**Follow-up actions arising from**  
**the Public Works Subcommittee Meeting on 21 February 2025**  
**on Reprovisioning of Victoria Public Mortuary**

At the Public Works Subcommittee meeting on 21 February 2025, Members requested the Government to provide supplementary information on the agenda item **25NB** - "Reprovisioning of Victoria Public Mortuary" (LegCo PWSC(2024-25)22). In consultation with the Architectural Services Department (ArchSD) and the Department of Health (DH), our consolidated response is as follows –

25NB  
重置域多利亞公眾殮房  
REPROVISIONING OF VICTORIA PUBLIC MORTUARY

現有岩洞平面圖  
EXISTING CAVERN  
FLOOR PLAN

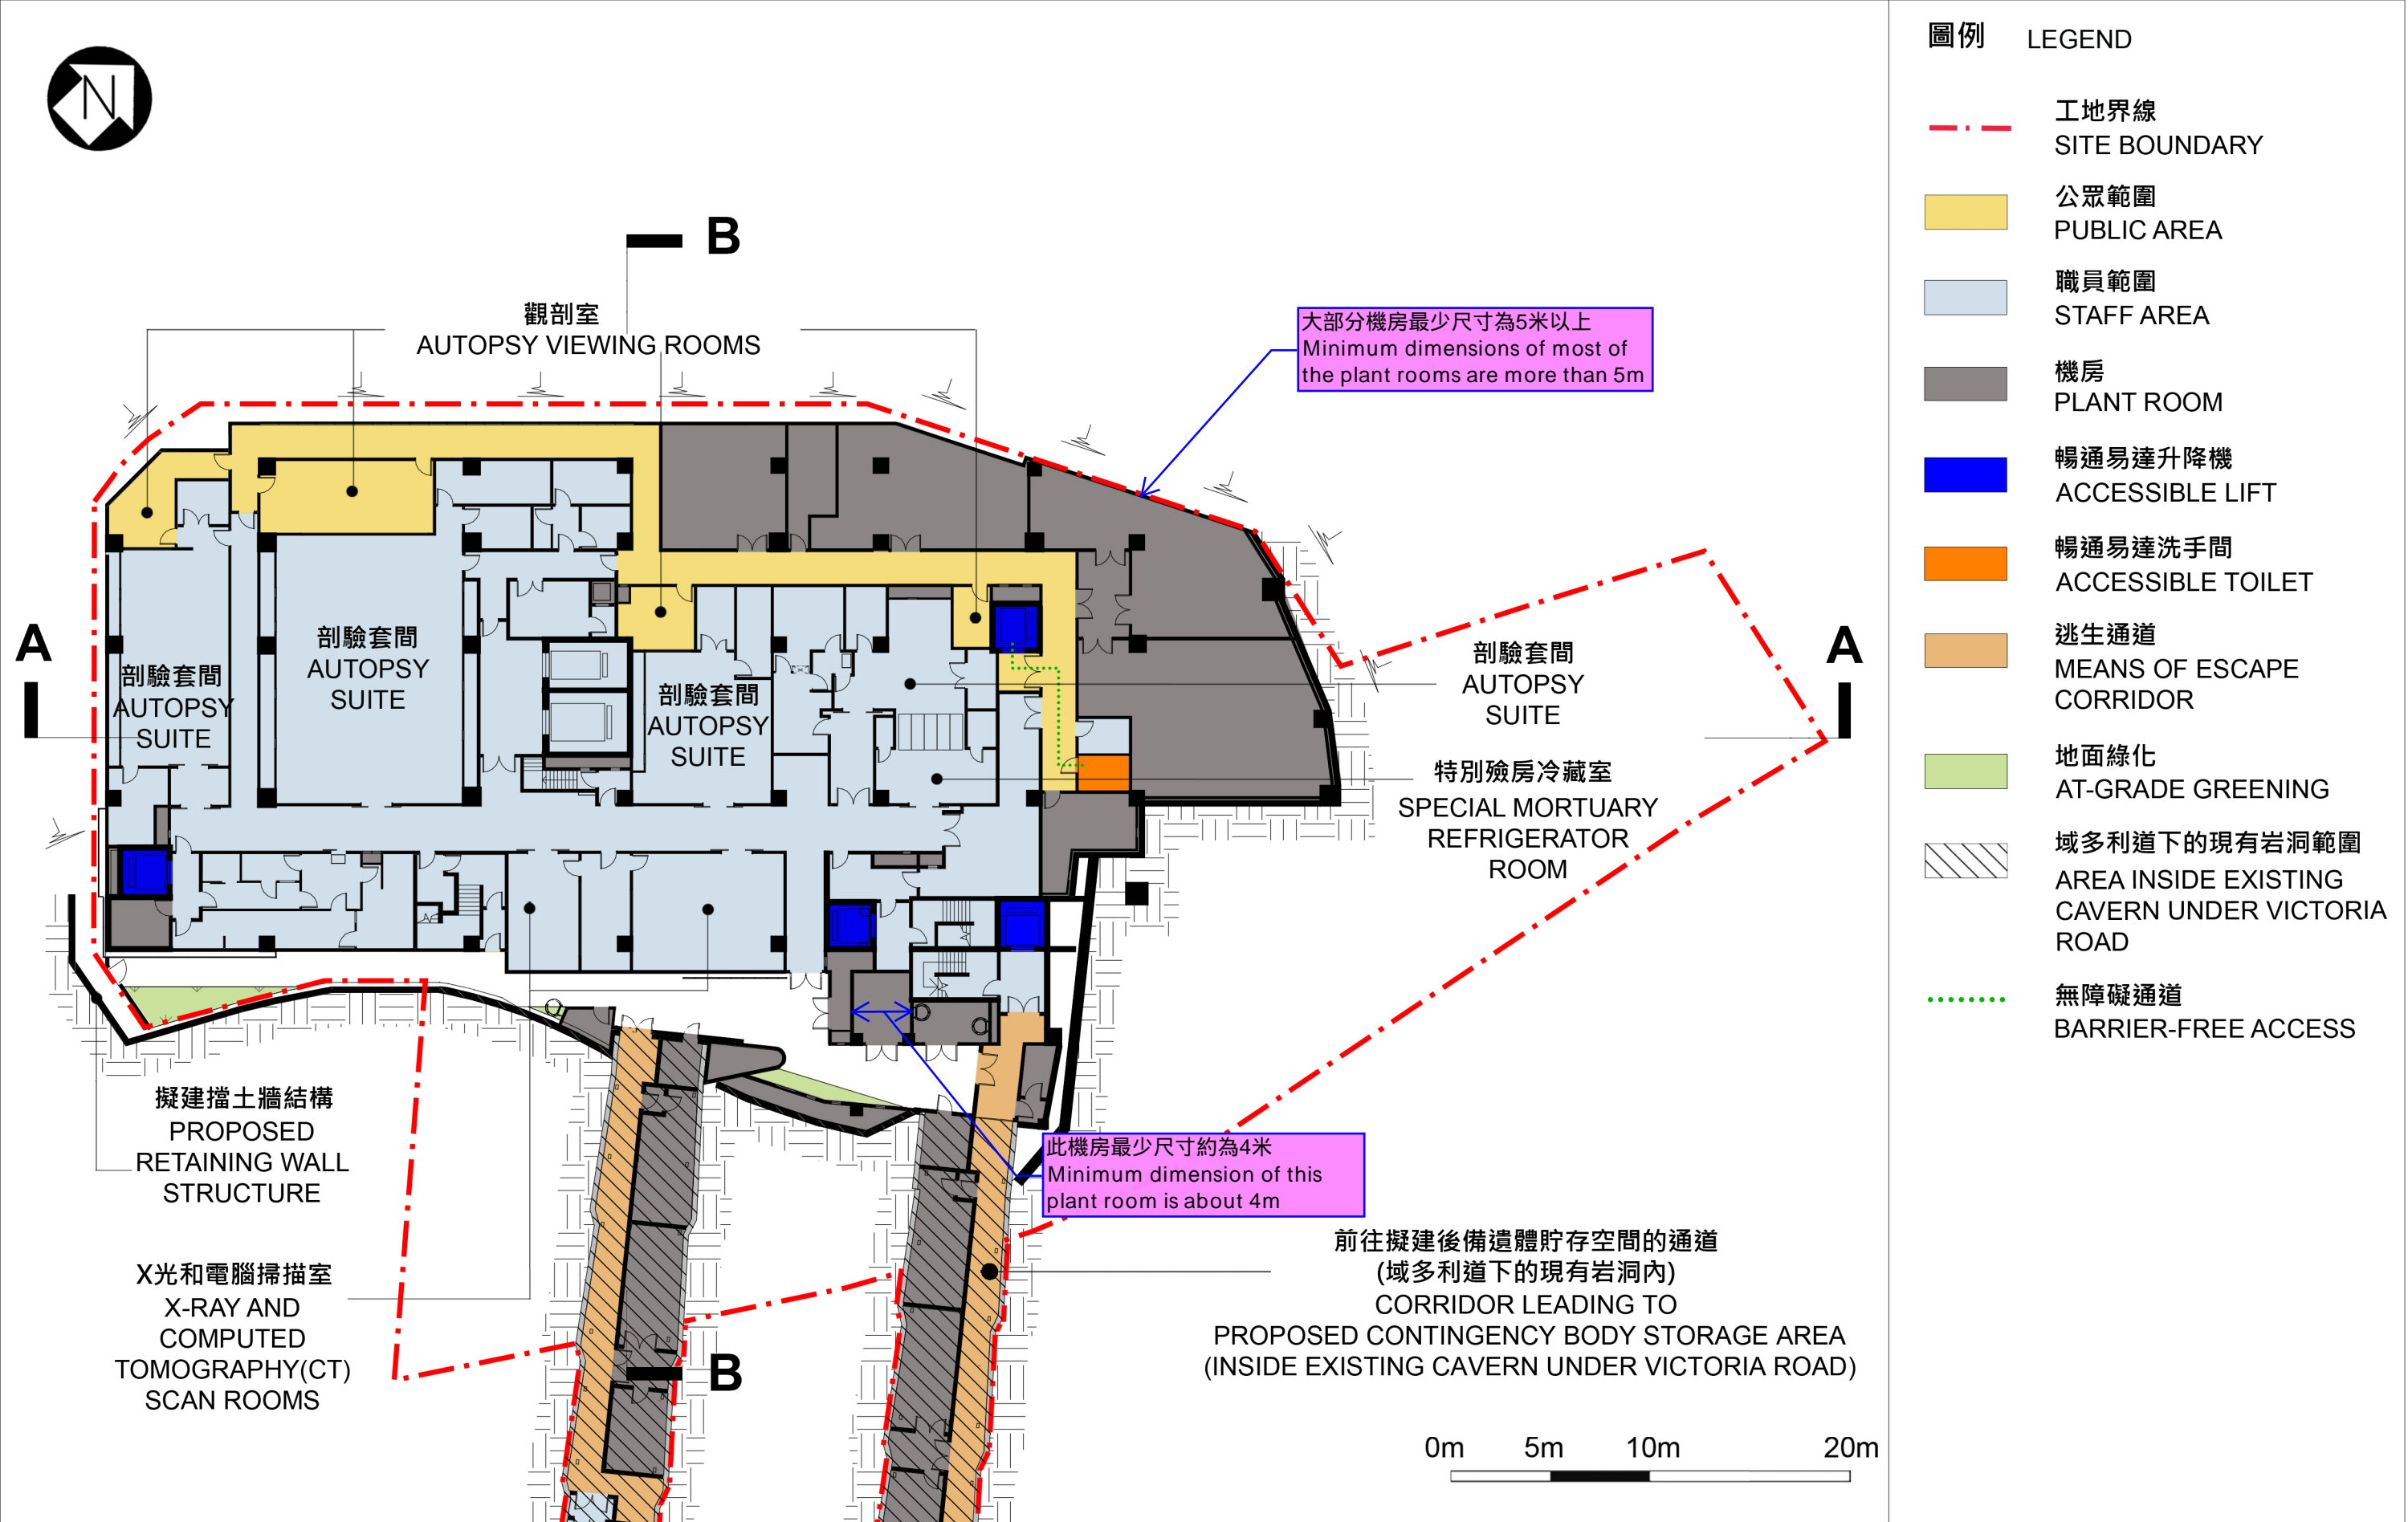
16. The width of the cavern ranges from 4 metres to 5 metres, while the minimum dimension of the plant rooms on the two lower ground levels of the mortuary building is about 4 meters. Since the fire safety design of the cavern needs to comply with the *Guide to Fire Safety Design for Caverns* issued by the Buildings Department, including the requirements for the provision of fire services systems (such as smoke extraction system) and means of escape, etc., the available space in the cavern is limited to a certain extent. Moreover, if the building services are relocated into the cavern, more wiring and pipe works are required than just storing MRMUs. The actual working space within the cavern will be further limited, thus rendering enhanced difficulty in carrying out maintenance and replacement works in future due to insufficient working

17. Please refer to **Annex III** for the available space inside the cavern.

18. In view of the above, the Government considers that the suggestion of providing building services (such as electrical plant room and pump room) in the cavern is not feasible.

地下平面圖  
GROUND FLOOR PLAN

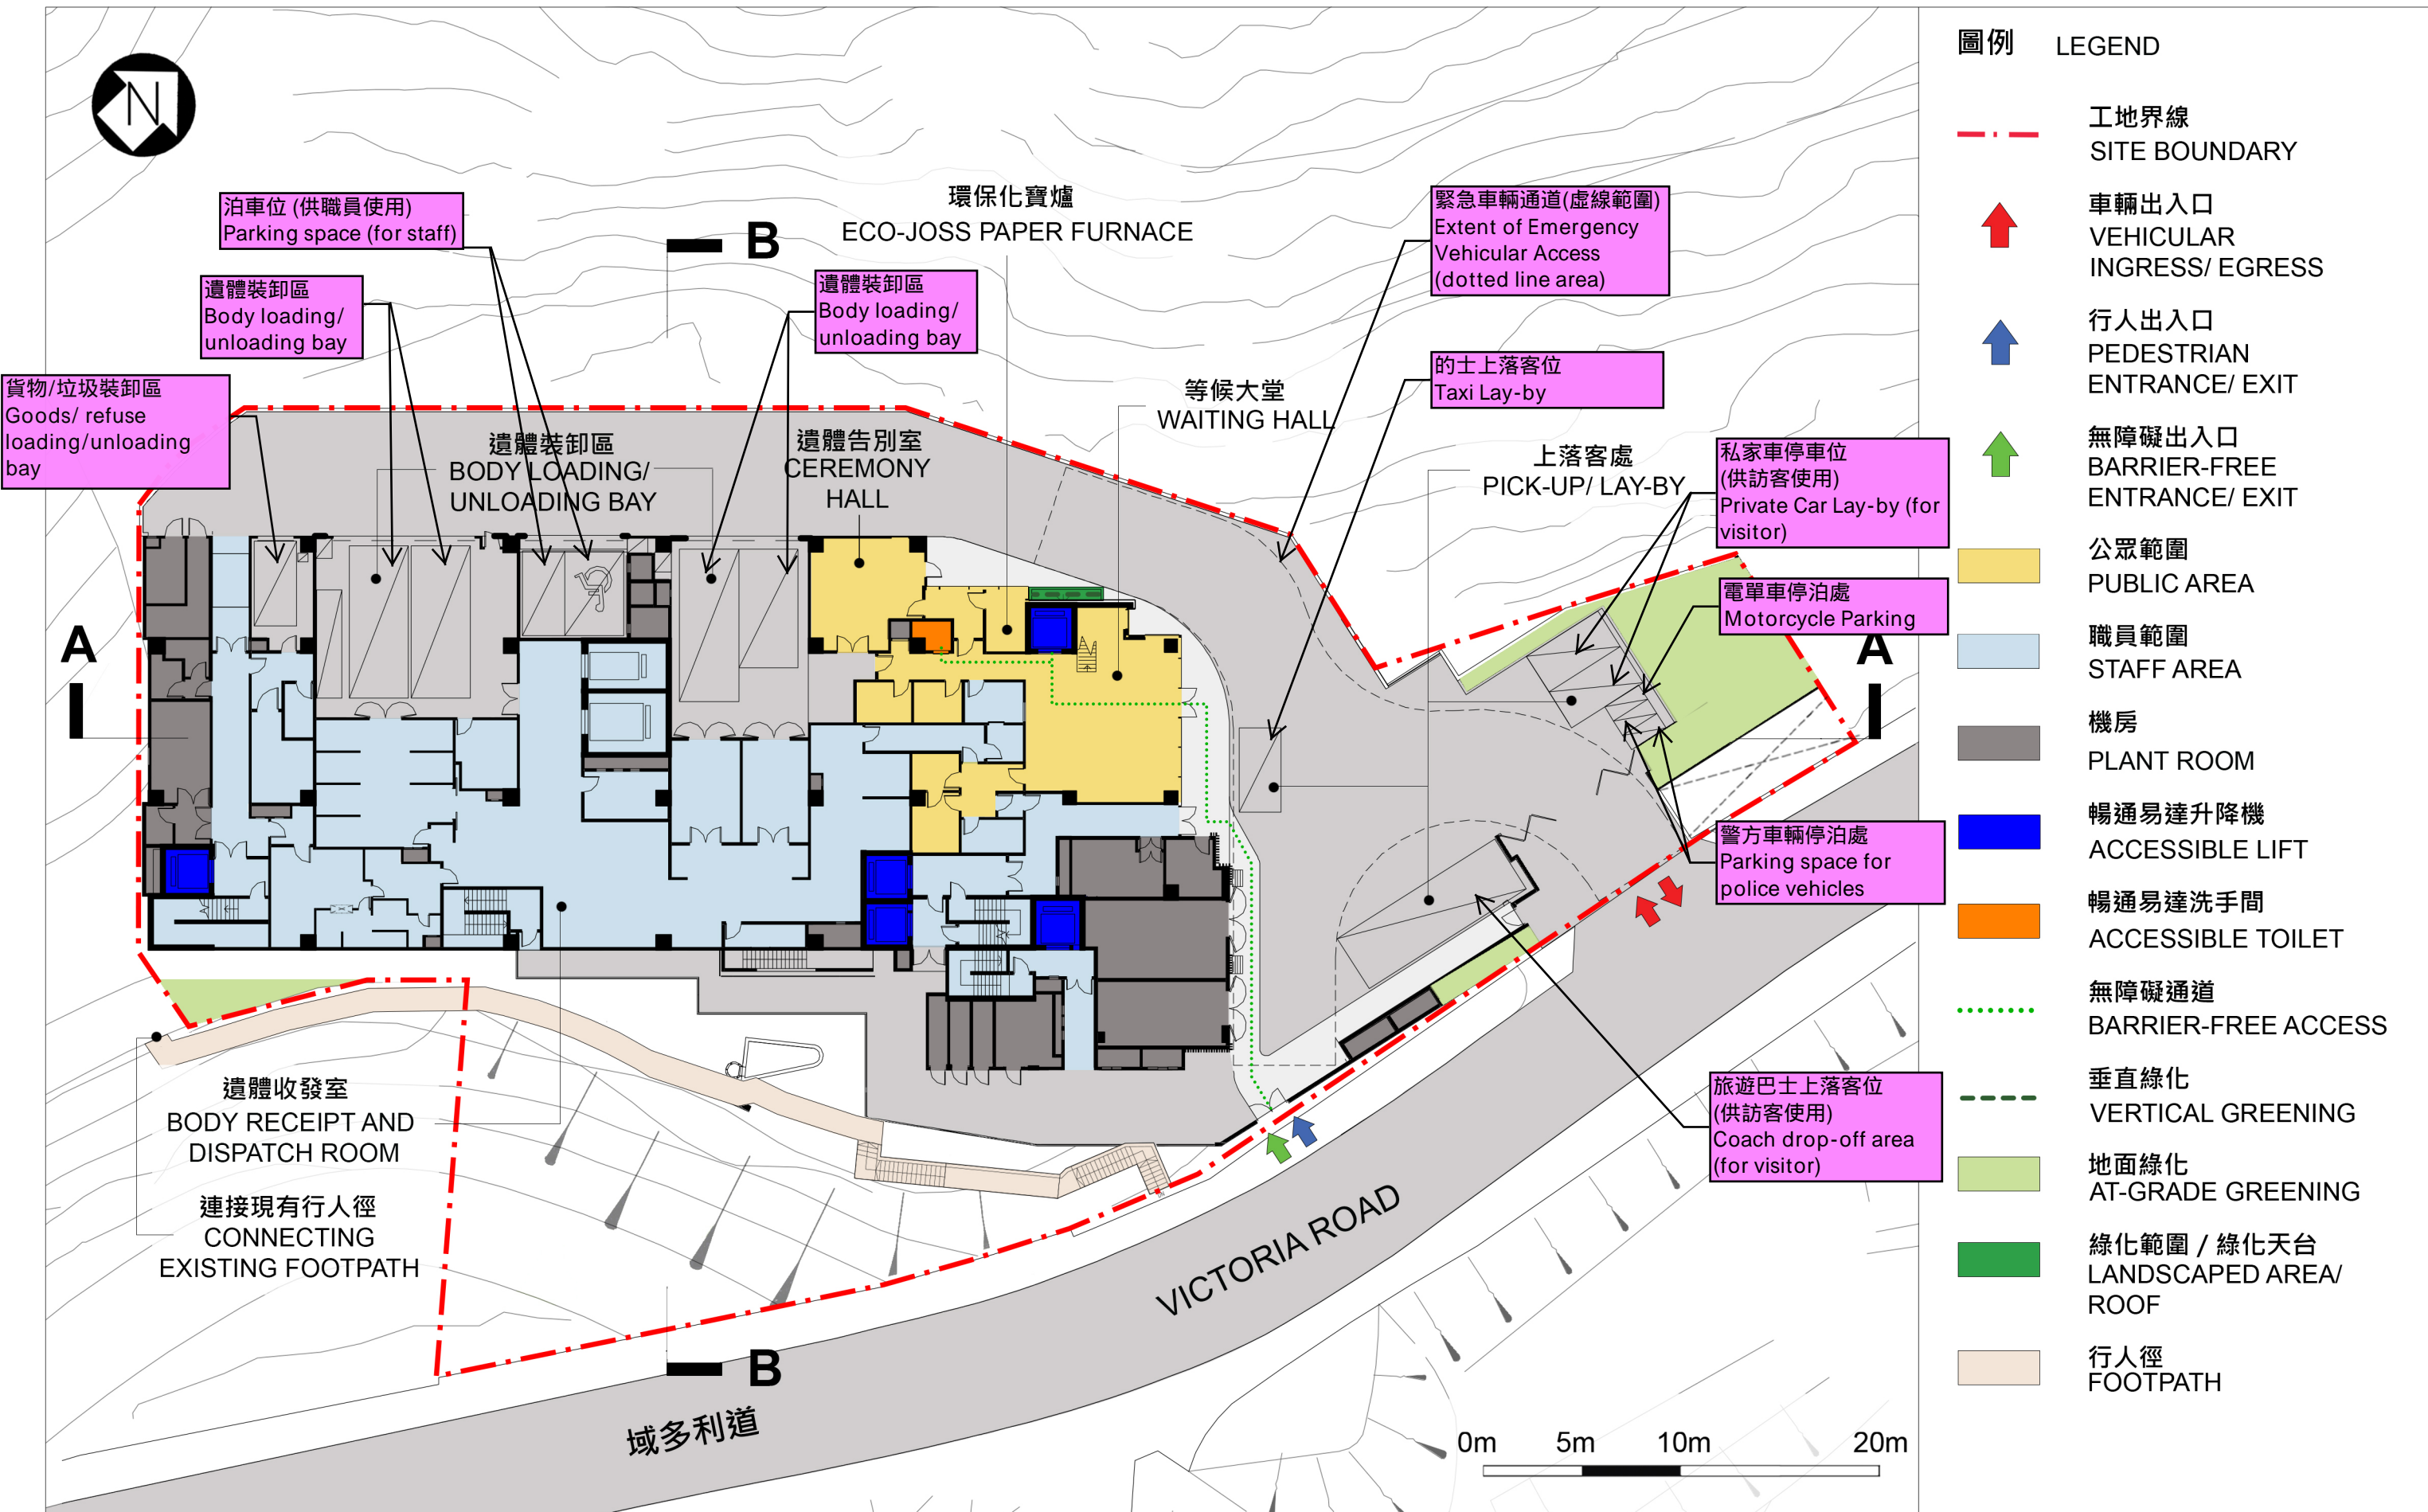
19. In response to Members' request, the Government has re-examined the feasibility of providing more parking spaces. Under normal circumstances, relatives and friends of the deceased will be arranged to visit public mortuaries at scheduled time slots to go through the procedures such as identifying and claiming the body. The proposed project will designate three lay-bys (including one taxi lay-by and two private car lay-bys) for visitors. Visitors who need to drive to the reprovisioned VPM may contact the staff of the Public Mortuary in advance so that the staff can make flexible arrangements and convert the private car parking spaces to into temporary visitor parking spaces.

20. In addition, the proposed project will also provide a coach drop-off area for visitors. Visitors in need may apply in advance with the public mortuary's staff when making an appointment. The DH will also flexibly arrange for other visitors in need to temporarily park their vehicles at the coach drop-off area when it is not used by coaches.

21. Please refer to **Annex IV** for the locations of parking spaces, vehicle lay-bys and drop-off areas.
